ENGINE - FUEL AND CONTROL - DEDICATED ALTERNATOR - DELETION OF COPPER LAMINATION -
CATEGORY CODE 6 - MOD.ENG-73-0026

V2500-ENG-73-0026

ENGINE FUEL AND CONTROL-DEDICATED ALTERNATOR,
STATOR UNIT. DELETION OF COPPER LAMINATIONS
FROM STATOR STACK (POWER).

Location of Dedicated Alternator
Fig.1

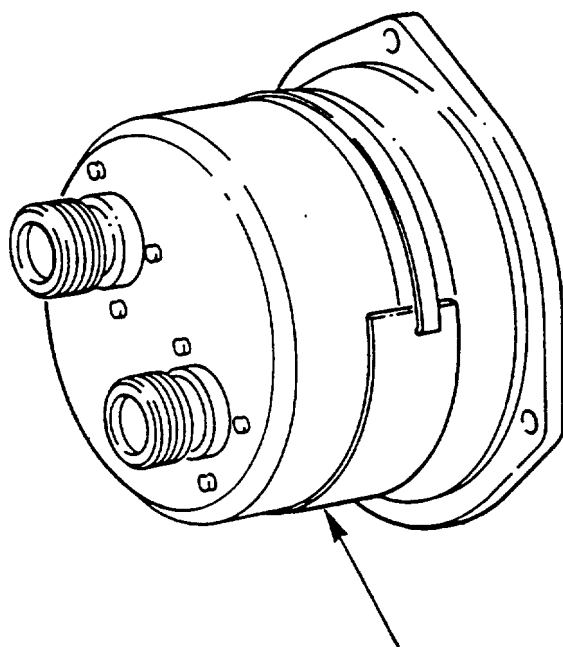
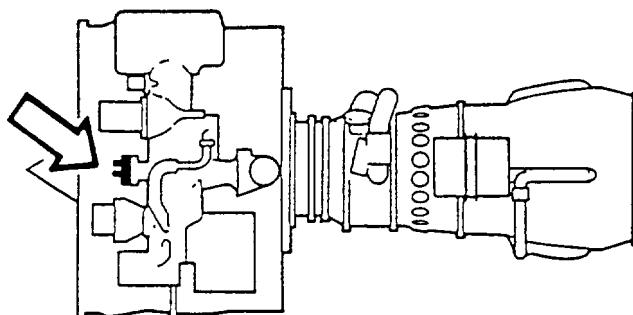
- (1) This Service Bulletin covers the fitment to engines of a dedicated alternator stator, with the copper laminations with equivalent iron laminates and other material changes to provide increased heat dissipation.

REMOVE 1664 MK3 DEDICATED ALTERNATOR
AND INSTALL 1664 MK4 DEDICATED ALTERNATOR
